PROJECT: 12-24
SSFUSD SSFHS ALTERATIONS TO ROOMS B-12 & B-13, AND C-3 & C-4

BID ADDENDUM NO. 2

March 26, 2026

A-102

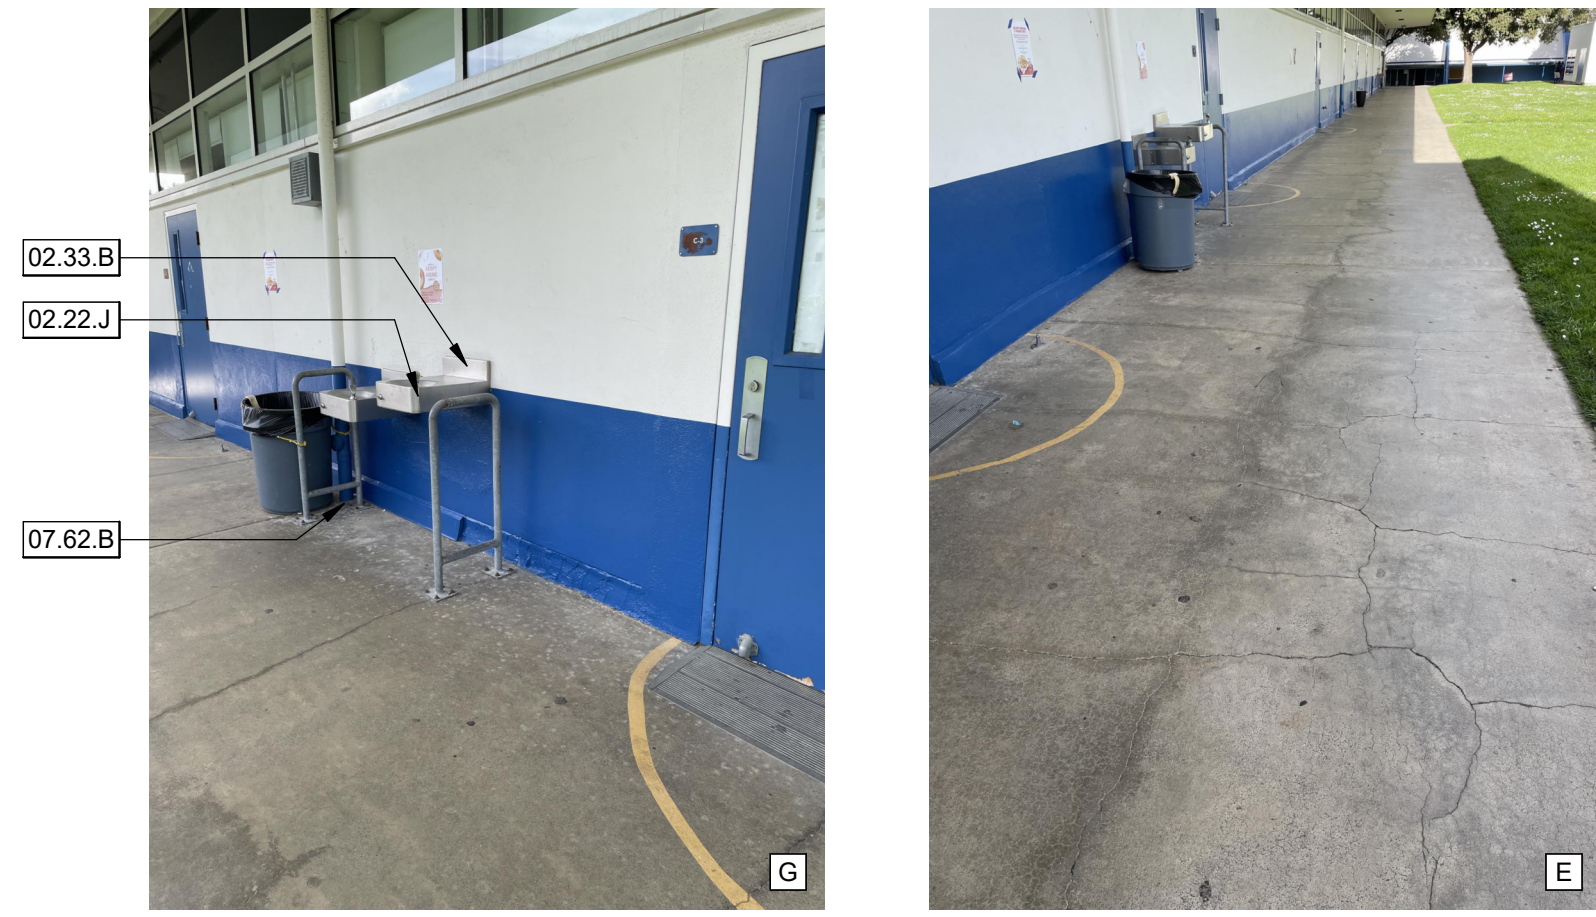
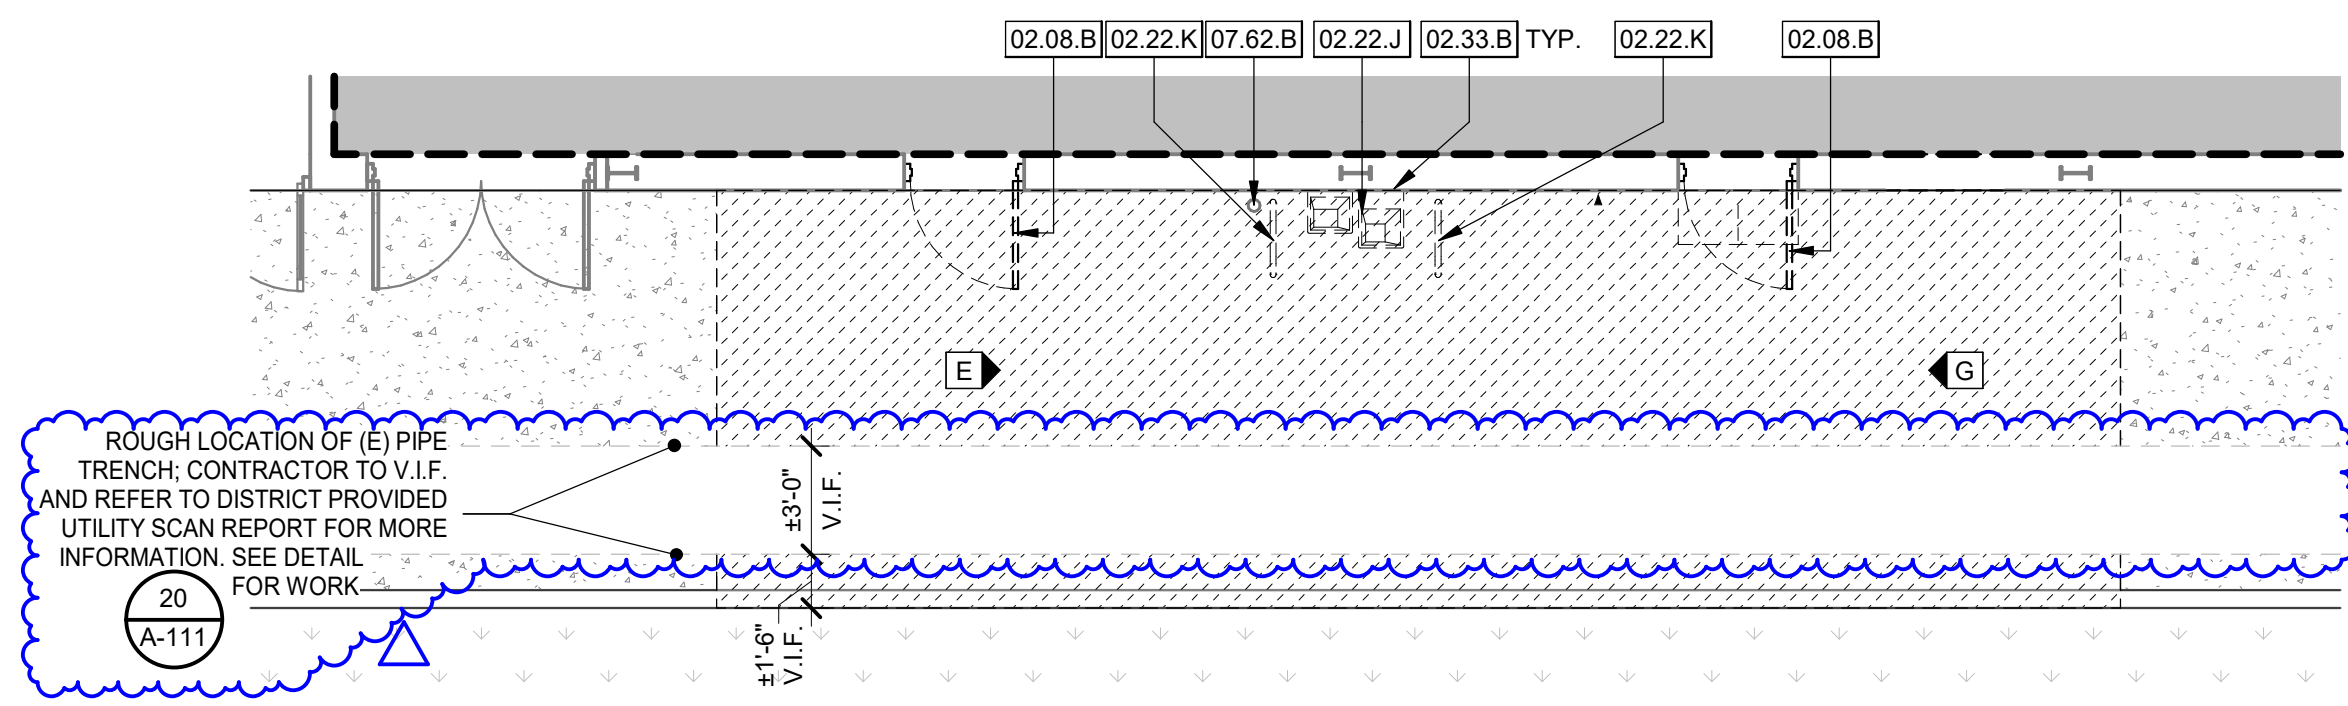
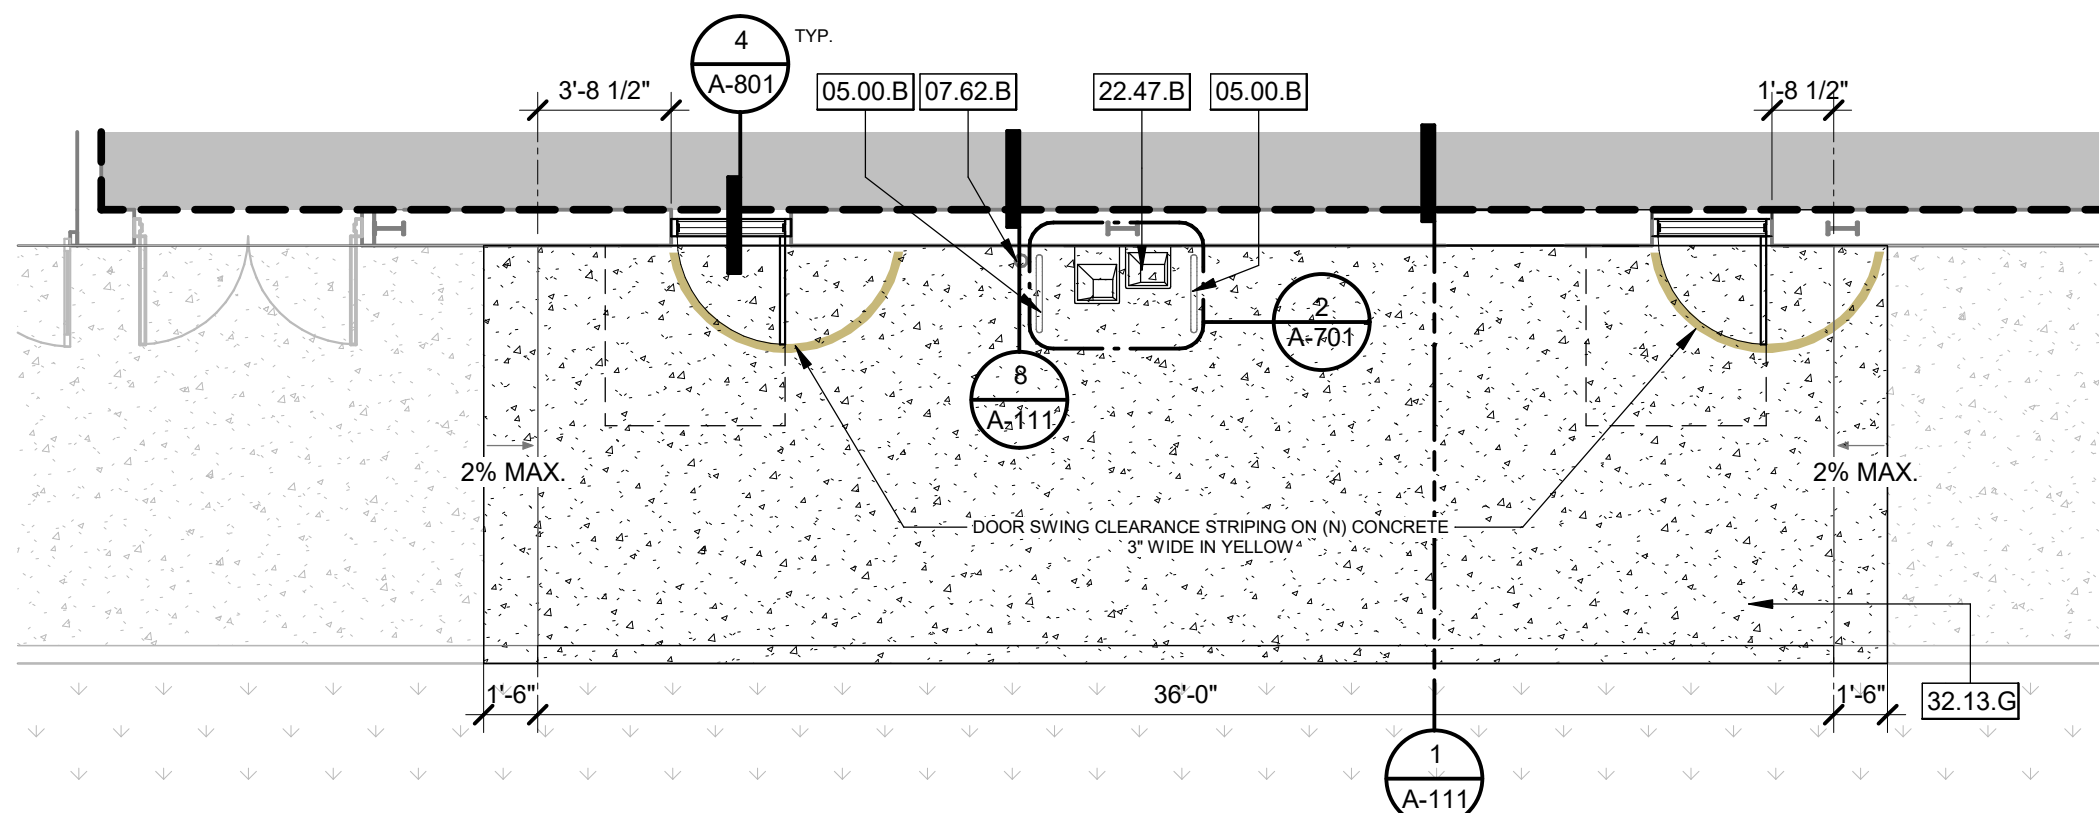
Revised Sheet A-102 to clarify Trench at Slab Demolition and View Reference.

A-111

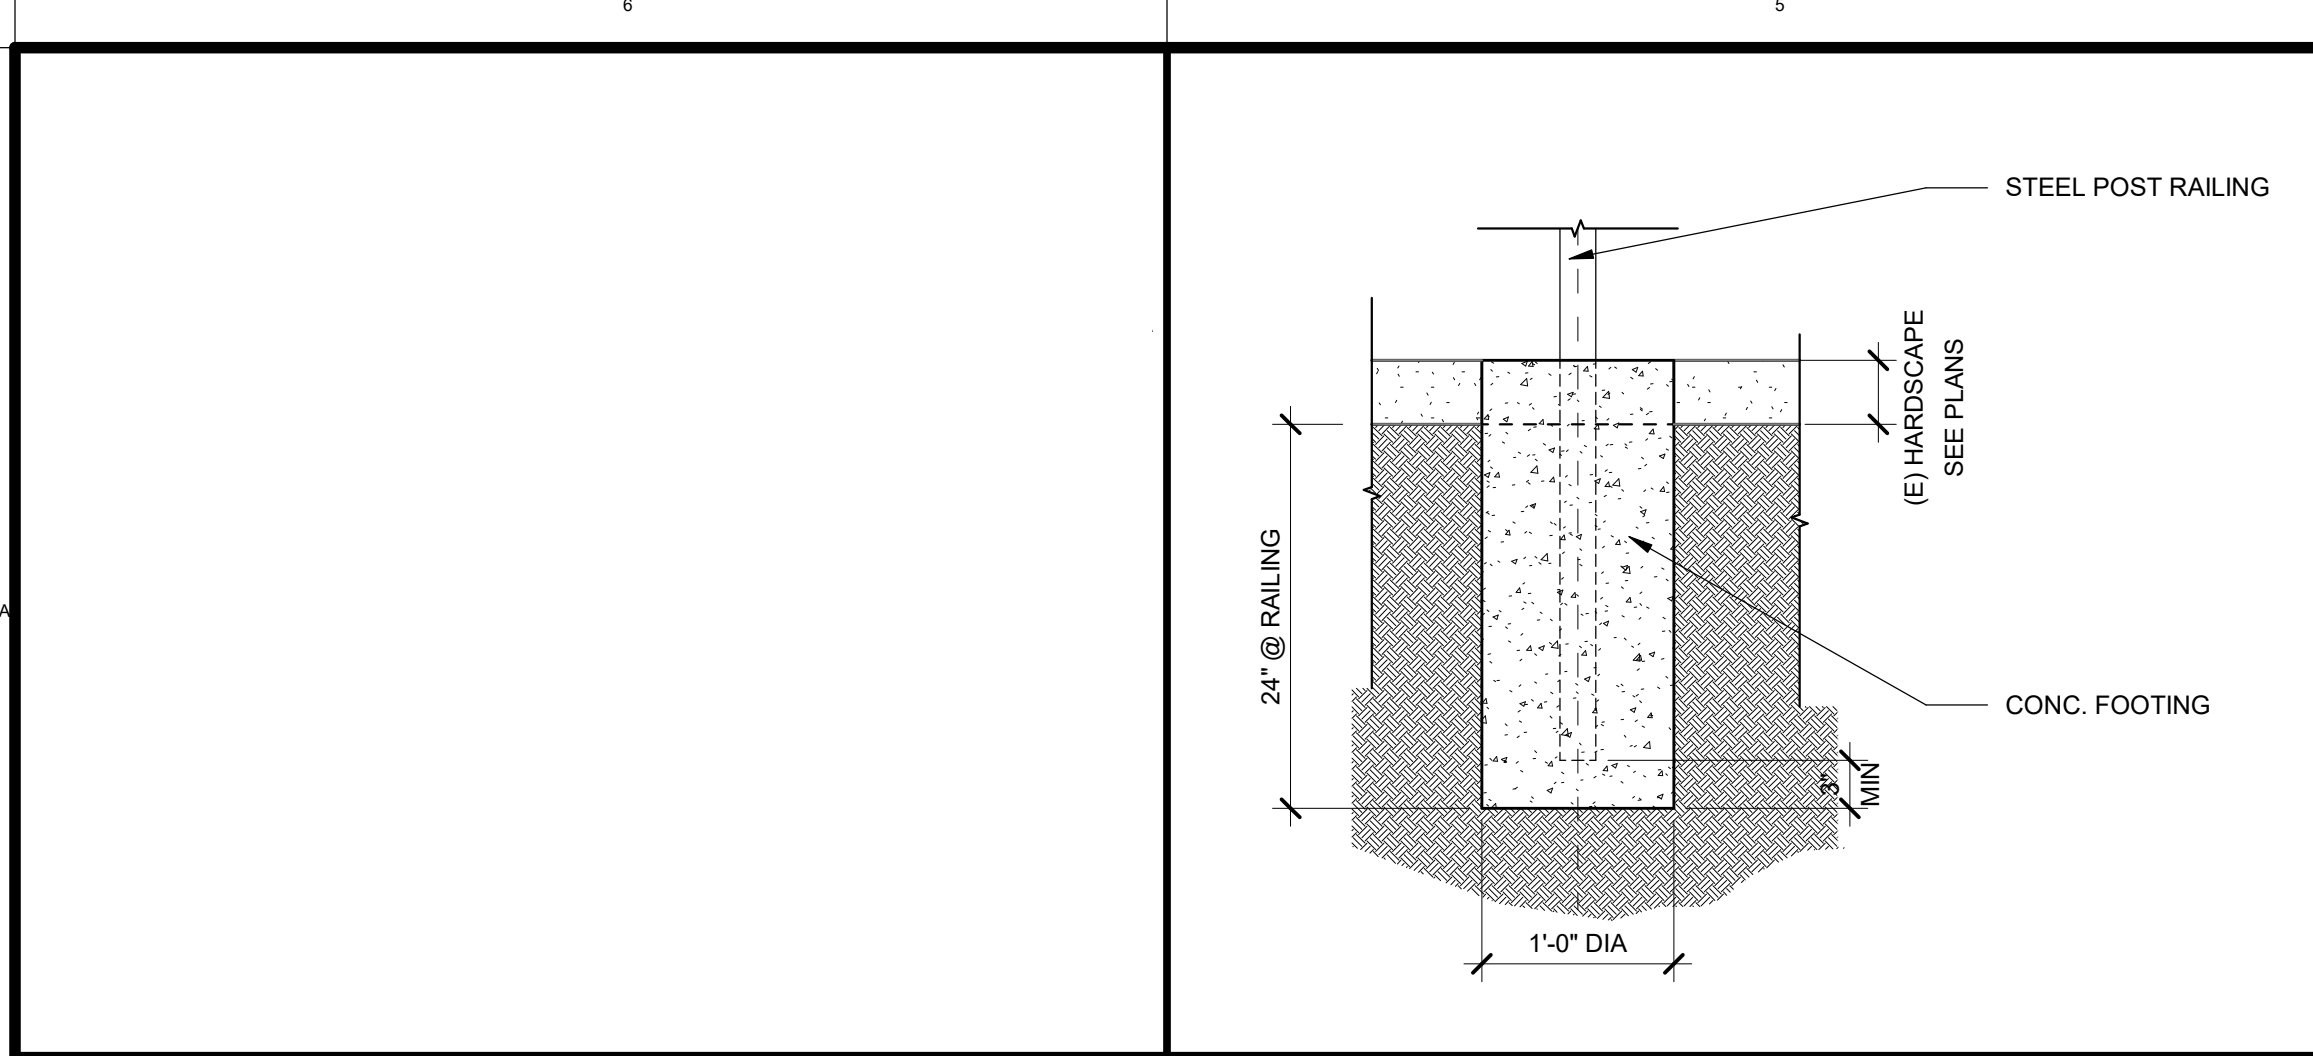
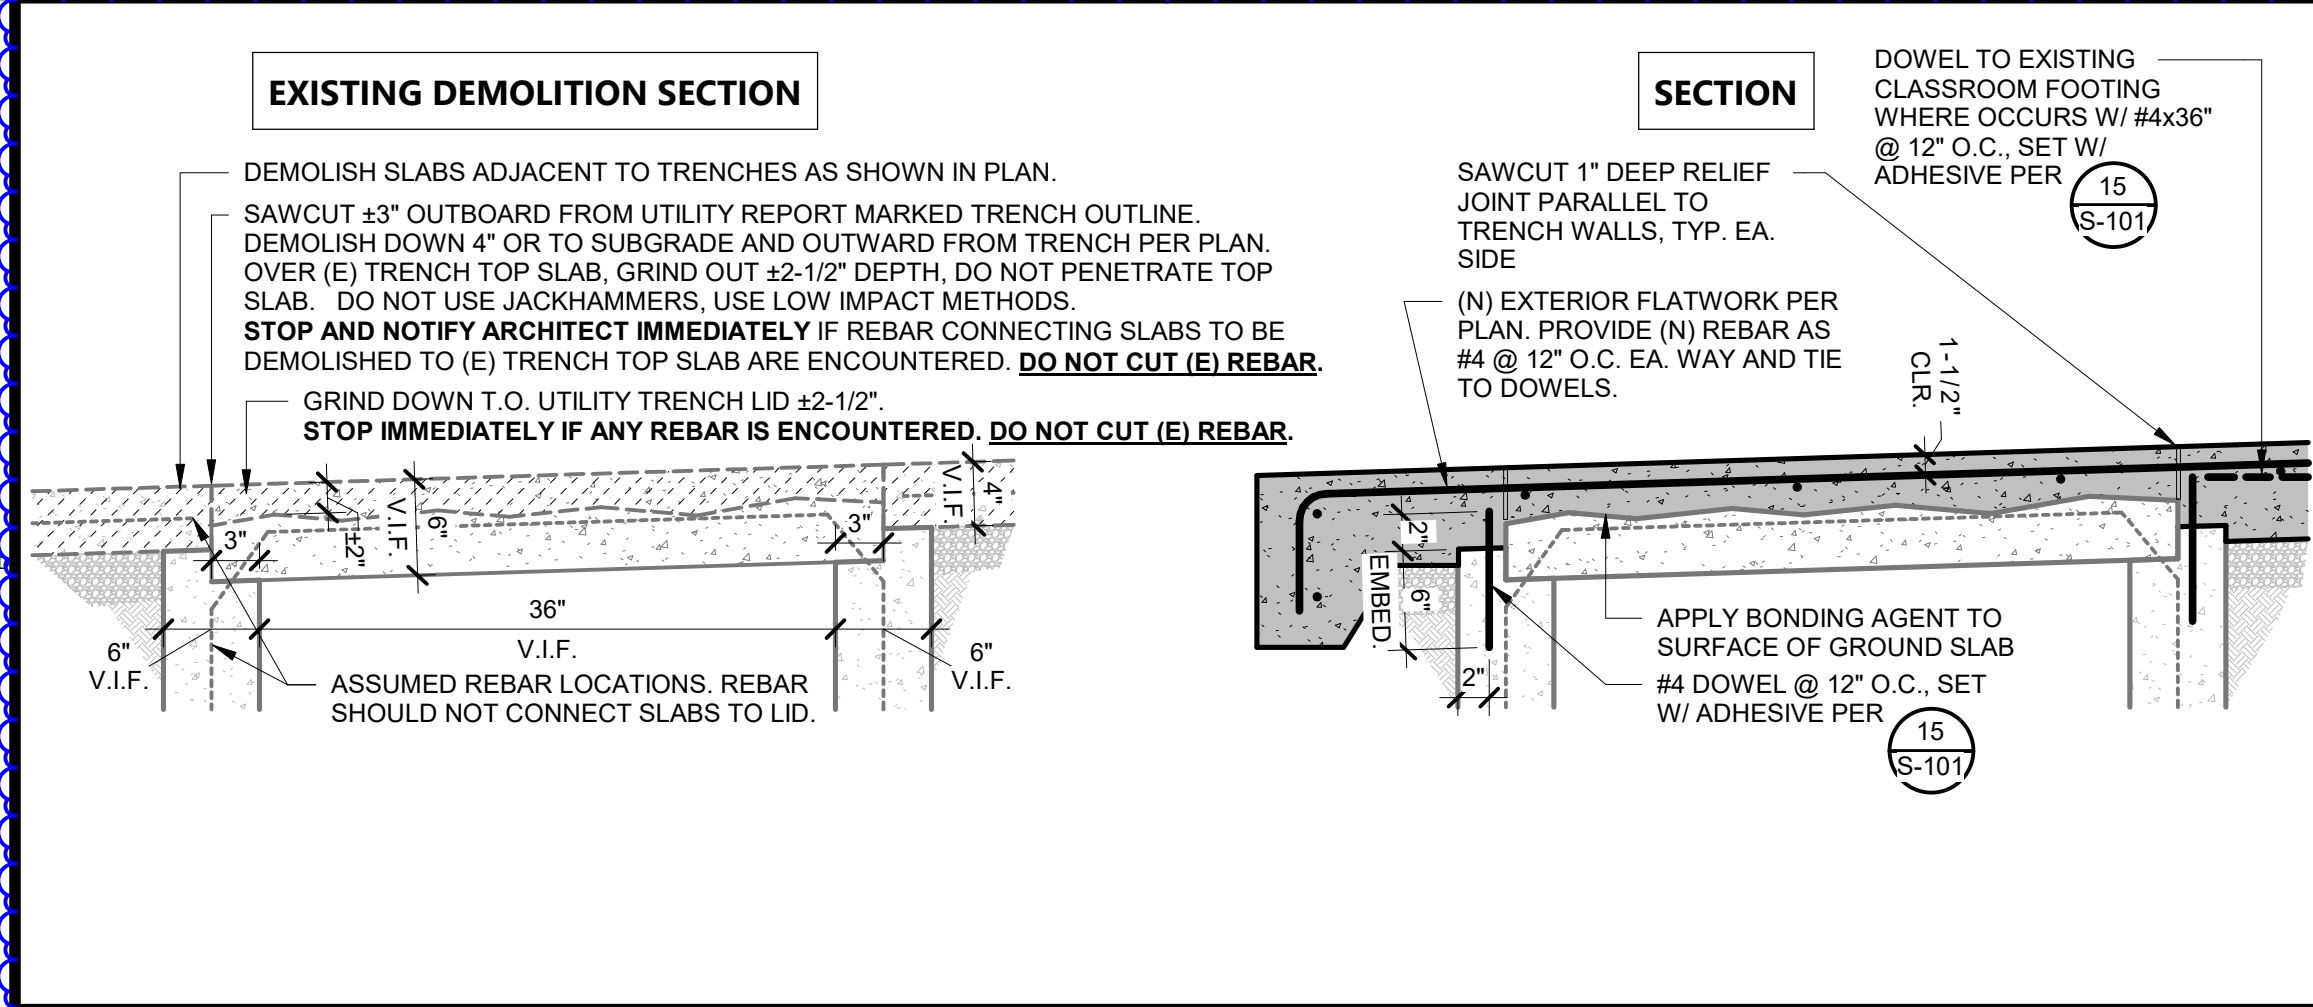
Revised Sheet A-111 to add Detail 20 clarifying handling of Utility trench at Slab Demolition.
